HARTZELL PROPELLER INC.
ALERT SERVICE BULLETIN
TRANSMITTAL SHEET
HC-ASB-61-313
Propeller - Counterweight Slug Bolt Inspection

July 15, 2009

This page transmits a revision to Alert Service Bulletin HC-ASB-61-313.

Counterweight Slug Attachment Bolt Identification
Figure 1

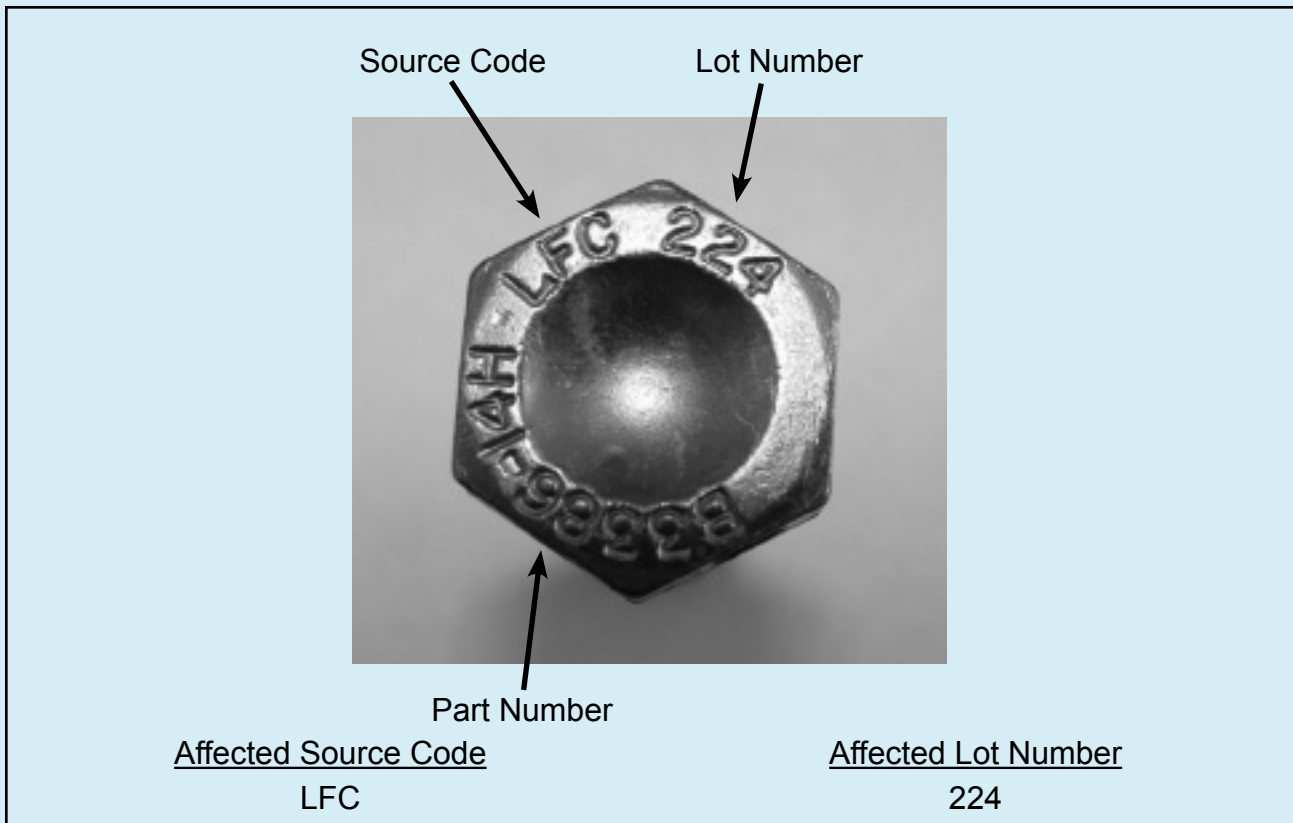
- (a) Locate the counterweight slug attachment bolts. Refer to Figure 2.
- (b) Inspect each B-3386-14H counterweight slug attachment bolt on the propeller for the affected LFC manufacturing lot. Refer to Figure 1.
 - 1 Bolts marked from another source code or lot number other than 224 are not affected by this Alert Service Bulletin.
 - 2 If only one counterweight slug attachment bolt on a counterweight slug is from the affected LFC manufacturing lot 224, both bolts may require replacement.
 - 3 Visually inspect all LFC manufacturing lot 224 counterweight slug attachment bolts for the following obvious signs of failure:

- (1) Inspect each B-3386-14H counterweight slug attachment bolt for the affected LFC manufacturing lot number. See Figure 1.
 - (a) Bolts marked from another source code or lot number other than 224 are not affected by this Alert Service Bulletin.
- (2) Immediately quarantine all affected bolts.

Figure 2

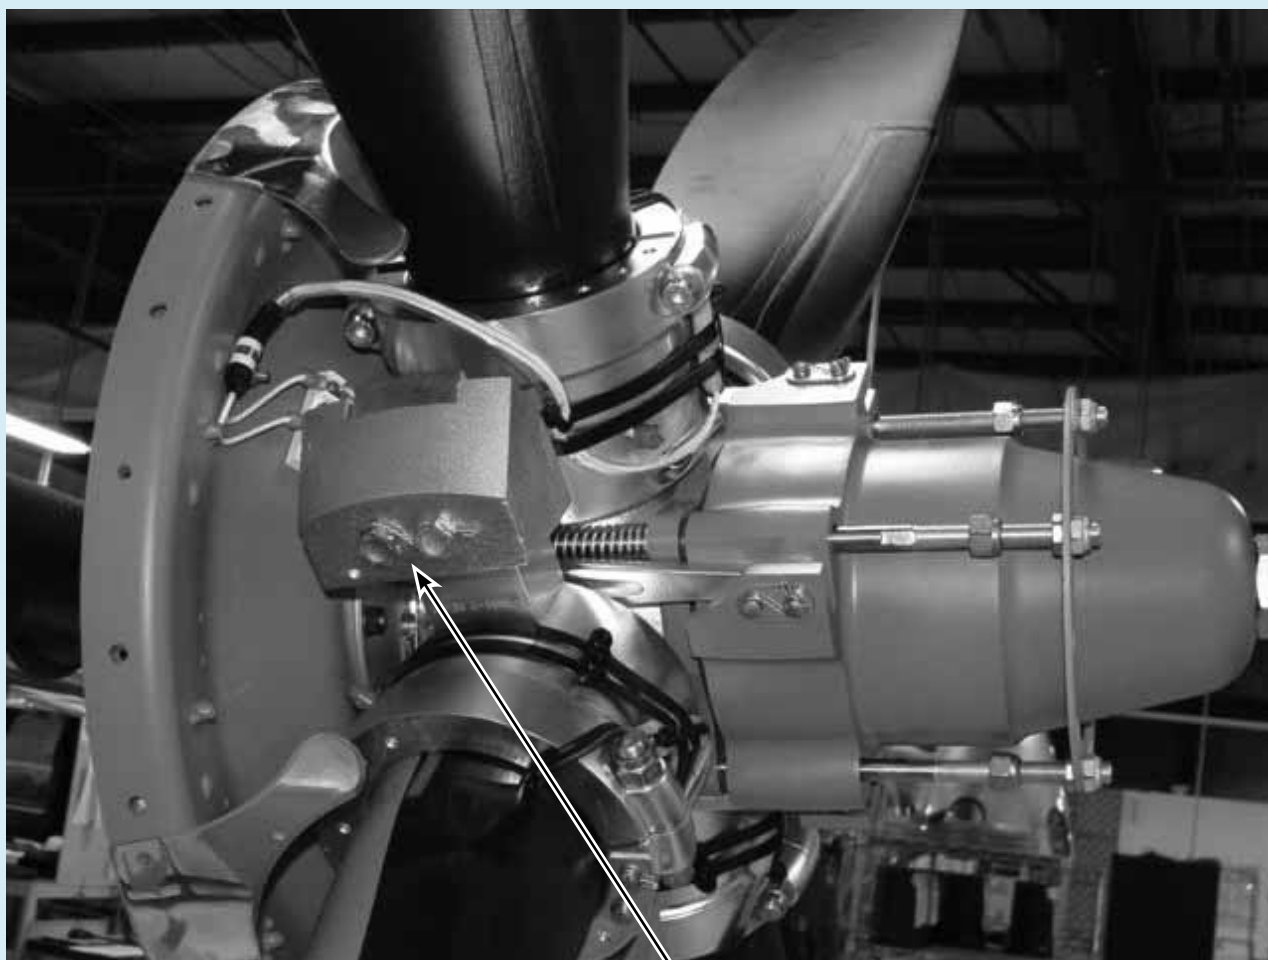
- Clarify that applications that have previously complied with an earlier version of this Alert Service Bulletin are not affected by this revision.
- Add HC-B4TN-5QL as an affected propeller in Table 1.
- Add reference and alternate method of compliance for FAA AD 2009-10-14.
- Modify compliance time to start from date of original issue instead of date of receipt.
- Clarify that one-time compliance is terminating action.
- Add Figure 2 to clarify location of affected bolts.

Inspect B-3386-14H bolts in this location
on each blade (two bolts per blade)
